Product Change Notification

Change Notification #: 117116 - 00
Change Title: Intel® Server System R2312WF0NPR,
Update BIOS/BMC/ME/FRUSDR,
PCN 117116-00, Product Design, Label,
System outer box J33994-001 stacking logo
update, 3.5" Tool-Less Carrier Design
Improvement for 2.5" Drive Support
Date of Publication: August 13, 2019

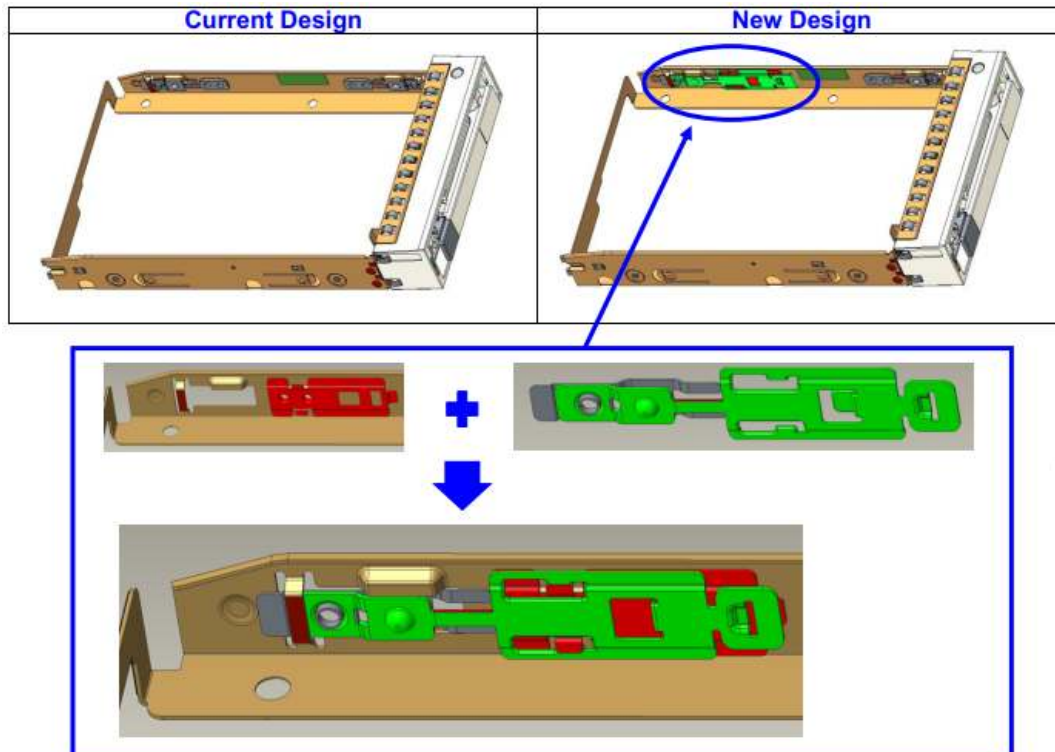
- Improvement for the 3.5" tool-less drive carrier when used for 2.5" drive support, from a non-removable to a new removable rear spring (see image in green) and new spring holder (see image in red) attached to the tool-less drive carrier.

Removing the new rear spring of 3.5" tool-less carrier when installing 2.5" SSD drive, installing the rear spring to support 3.5" HDD.
